TRUCK, AMBULANCE, LIGHT, 4 LITTER, FFR, WINCH, MC2-LAND ROVER 110 6X6

RELOCATION OF THE SEVEN PIN AUXILIARY PLUG AND HARNESS ASSEMBLY

MODIFICATION INSTRUCTION

Figure 1 - Existing 7 Pin Auxiliary Plug Location

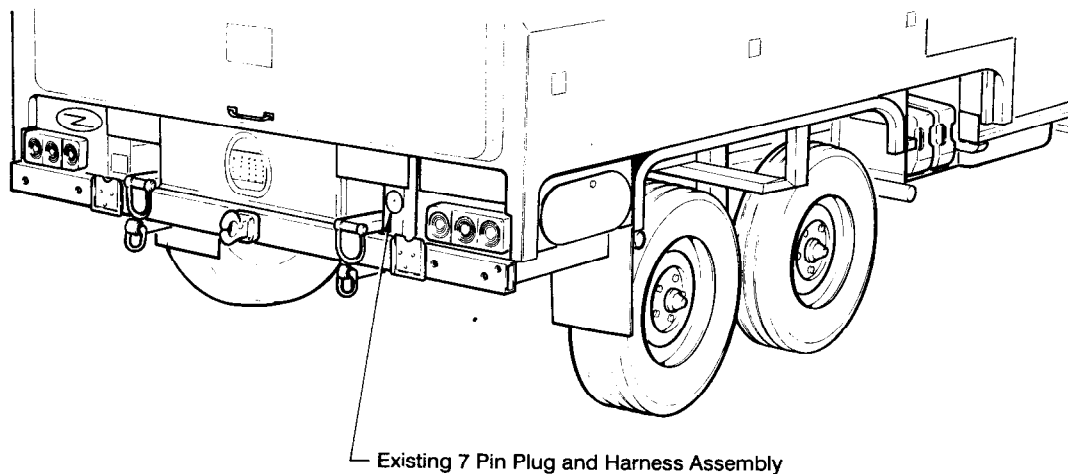
1. This instruction details the relocation of the seven pin auxiliary plug and harness assembly from the outside face to the inner side of the right rear chassis upright, to prevent damage to the wiring during off road operation. A new bracket has been introduced to mount the plug and harness. The relocation of the plug was carried out in production from Jul 90 and rework only affects early ambulance variants.

10. **Proceed as follows:**
  - a. Disconnect the vehicle battery.
  - b. Locate the existing 7 pin auxiliary plug on the right rear chassis upright, as shown in Figure 1.
  - c. Disconnect the plug cable from the chassis harness at the multi pin connector located on the rear chassis rail and the earth wire at the bullet connector.

**Figure 2 - Position of 7 Pin Auxiliary Plug Mounting Bracket**

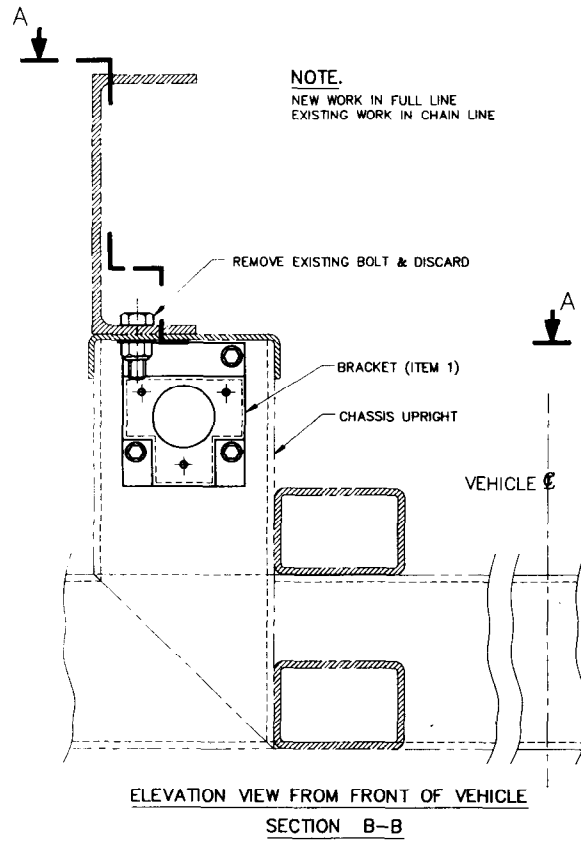
- e. Remove the chassis bolt then position and secure the new bracket (Item 1) to the front face of the upright from which the plug has just been removed using screws, nuts and washers (Items 2,3,4) as shown in Figure 2.

**Figure 3 - Relocated 7 Pin Auxiliary Plug**

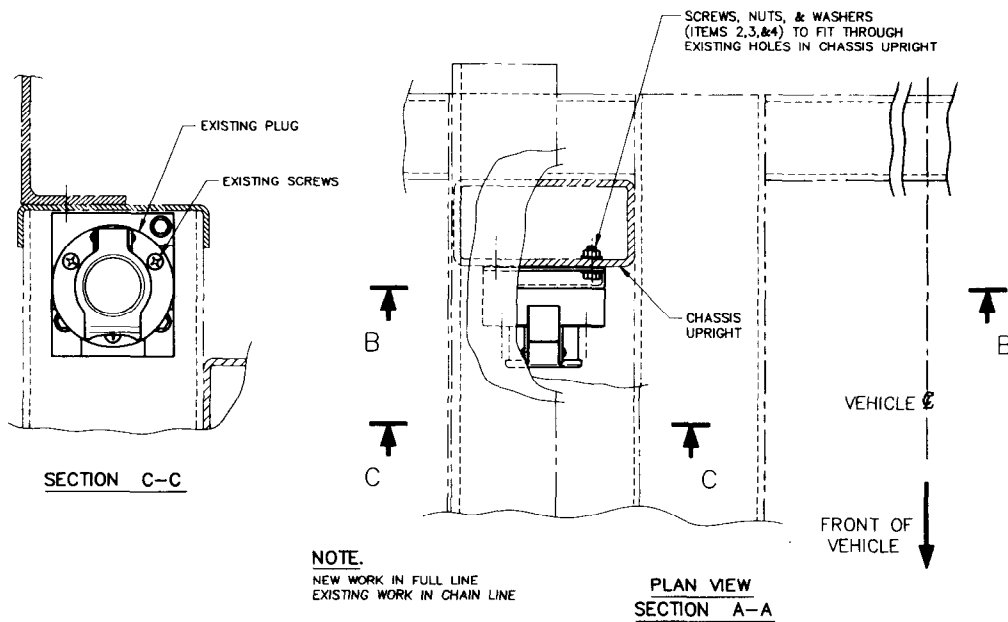
- f. Pass the plug cable and connector through the mounting bracket and then through the chassis upright, feeding all the cable through the hole.
  - g. Secure the 7 pin plug to the bracket using three original screws as shown in Figure 3.
